Application Number	PT8GC231
Applicant Name	Galway County Council
Development Address	Eanach Dhúin/ Annaghdown Co. Galway

Name	Robert Mulryan
Address	Eanach Dhúin Cor an Dola Co. na Gaillimhe
Note	See attached.

RECEIVED: 26/05/2025

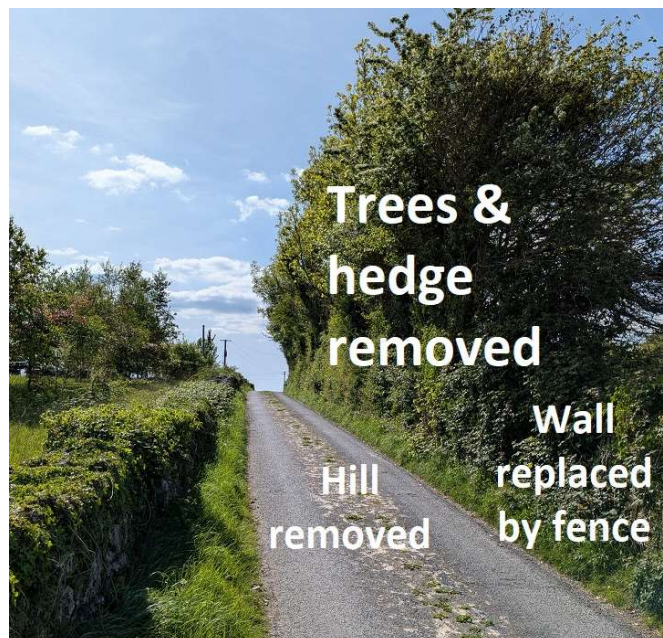
1. The entrance to the graveyard should be on the main road

The proposed design has only 1 way in and 1 way out and will be a bottleneck during burials. Having an entrance on the main road will allow traffic to get away quickly in 2 directions like the current graveyard.

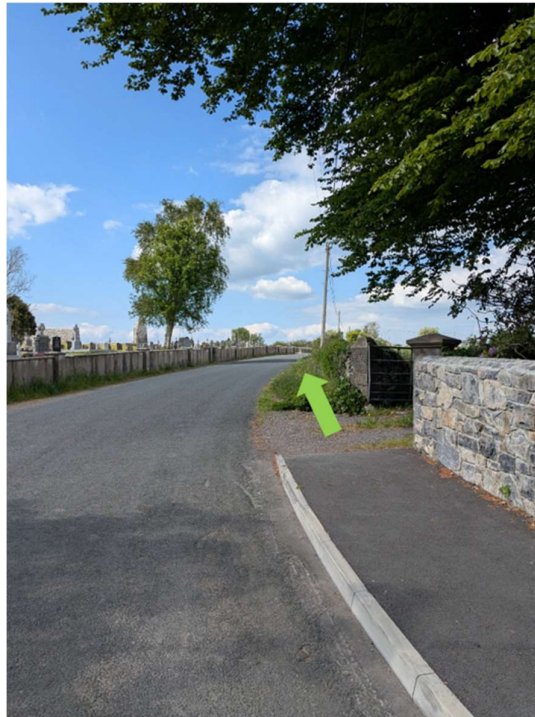
2. The council must buy the whole field

- Proposed graveyard could be full again in 30 years
The proposed graveyard has 315 plots and the parish has 10 bereavements per year. Therefore, the proposed graveyard could be full again in just over 30 years (probably much sooner as the graveyard is not restricted to people with a link to the area). It took around 10 years to find this field, will it be possible to find another field in 30 years?

- To have a graveyard for the next 100 years
The council must buy the entire field to provide a graveyard for the next 100 years. Per the councils burial ground policy, the council pays agricultural prices for land (approx. €10,000/acre). There is about 3 acres remaining in the field. The €30,000 needed to buy the rest of the field could be easily funded by the presale of around 40 double plots. (€726 each). This opportunity to buy the whole field must be taken to future proof the graveyard needs of the area.

4. How do cars parked on the access road leave after burials?

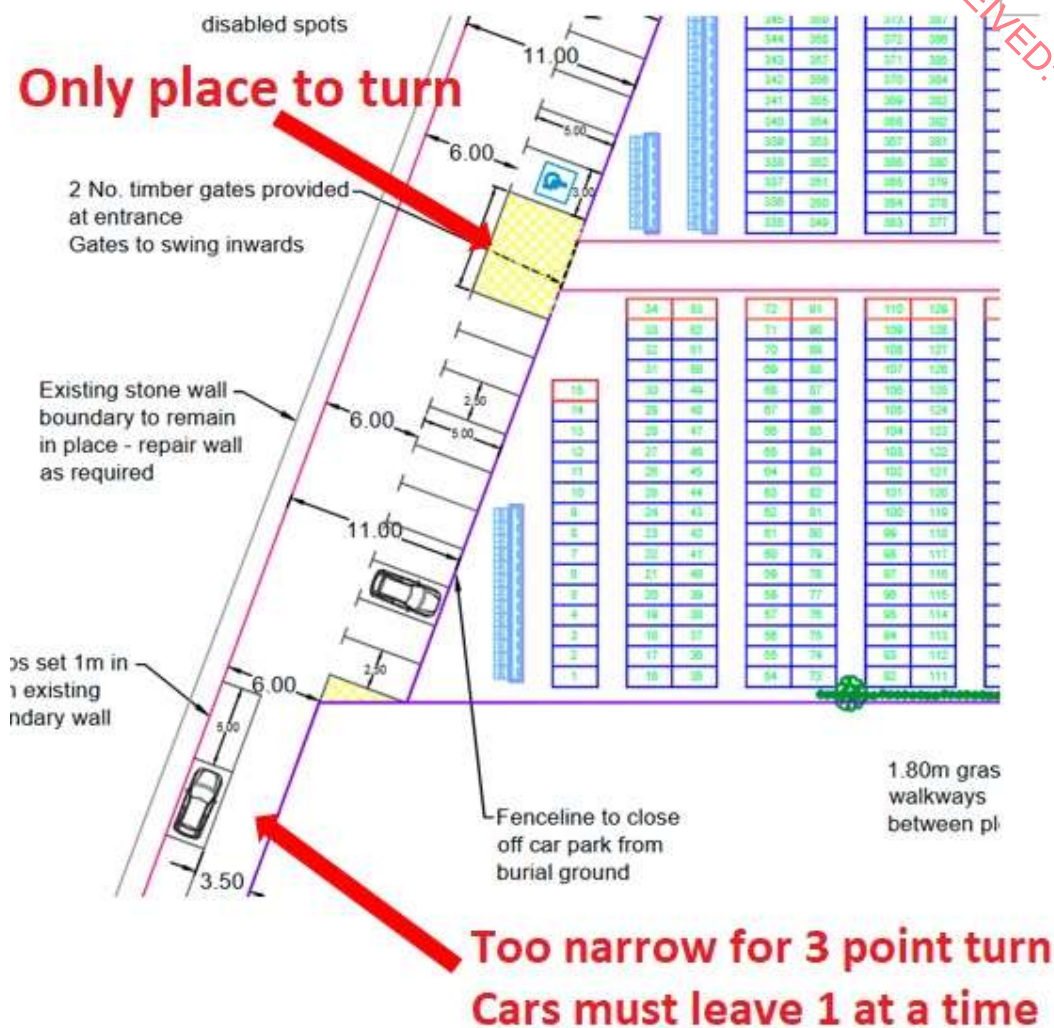
- After burials, the cars parked on the access road will leave before the family cars parked at the graveyard.
- The access road is too narrow to do a 3-point turn.
- Cars parked on the access road must drive up to the graveyard gate to turn.
- 1 car leaving blocks the access road so cars must leave 1 at a time slowing everything down.
- People looking for a discreet and efficient get away after a burial will naturally park on surrounding roads & outside houses which creates unnecessary health & safety risks.
- A normal car park on the main road cuts out all these unnecessary problems.
